Access Compliance Report

Public Rights-of-Way

(Curb Ramps)

Intersection ID: 49393	Main Street: ROMANA_RED_LN	Cross Street: AUBRAC_LN	Location: SE
ADA ID: 283C4372E61F	Ramp Type: Perp	Initial Pass/Fail: Pass	Overall Compliance: No
Severity Score: 0.25			
Codes/Mitigation Info/Possible Solution		Field Measurements/Component Compliance

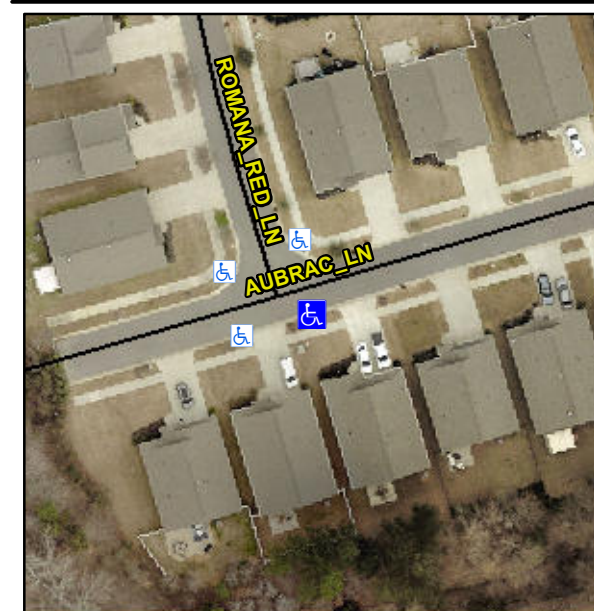
Not Found, R305.2

Compliance	Description	Data	Compliance	Description	Data
N/A	Ramp Length (in)	71.0	Yes	Ramp Slope (%)	7.0
Yes	Ramp Width (in)	48.0	Yes	Ramp XSlope (%)	2.1
N/A	Flare Type LT	Sloped	N/A	Flare Type RT	N/A
N/A	Flare Slope LT (%)	4.8	N/A	Flare Slope RT (%)	3.1
N/A	Flare Traversable LT?	No	N/A	Flare Traversable RT?	No
Yes	Landing Length (in)	59.0	Yes	DWS Provided?	Yes
Yes	Landing Width (in)	103.0	Yes	DWS Contrast?	Yes
Yes	Landing Slope (%)	0.1	Yes	DWS Length (in)	24.0
Yes	Landing X Slope (%)	1.3	Yes	DWS Full Width?	Yes
N/A	Landing Curb? (Y/N)	No	No	DWS Offset (in)	4.0
N/A	Shared Landing?	No			
Yes	Gutter Ponding?	No	Yes	Gutter Slope (%)	1.4
Yes	Gutter Lip Ht (in)	0.0	Yes	Gutter X Slope (%)	1.3
N/A	Painted X Walk1?	No	N/A	Painted X Walk2?	N/A
	X Walk 1 Direction	To N		X Walk 2 Direction	N/A
N/A	X Walk 1 Width (in)	N/A	N/A	X Walk 2 Width (in)	N/A
	X Walk 1 Slope (%)	2.8		X Walk 2 Slope (%)	N/A
	X Walk 1 X Slope (%)	4.8		X Walk 2 X Slope (%)	N/A

N/A	Ramp inside XWalk1?	N/A	N/A	Ramp inside XWalk2?	N/A
	Road Slope (%)	N/A	N/A	Clear Space?	Yes
	Road X Slope (%)	N/A	N/A	Clear Space to XWalk (in)	N/A
Yes	Any Obstructions?	No	Yes	Storm Grate/Utility Hazard?	No
	Obstruction Type			Storm Grate/Utility Type	
		N/A			N/A
			Yes	Surface Condition? (G/P)	Good

Remove & Replace Entire Ramp.
